ISSUE NO. : 09-009	DATE : 23 Sep. 2009	PAGES : 1 OF 1
--------------------	---------------------	----------------

SUBJECT	MODIFICATION OF CLUTCH OUTER COVER
MODEL	GT-650, GV-650
EFFECTIVE F/M NO	REFER TO APPLICATION

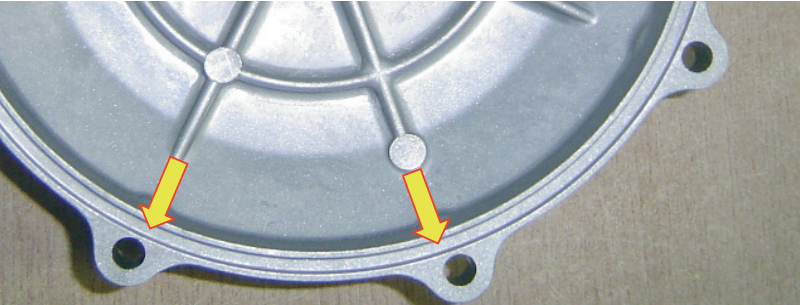
→ TO AVOID AN OIL LEAK FROM CLUTCH OUTER COVER.

→ MODIFICATION OF O-RING JOINT

PICTURE	DESCRIPTION
<p><BEFORE></p> 	<p>Joint groove of O-ring is connected with screw hole. When a screw is tightened the screw pushes the O-ring and it causes an oil leak through the hole.</p>
<p><AFTER></p> 	<p>Modification of shape to avoid interference between a screw and O-ring.</p>
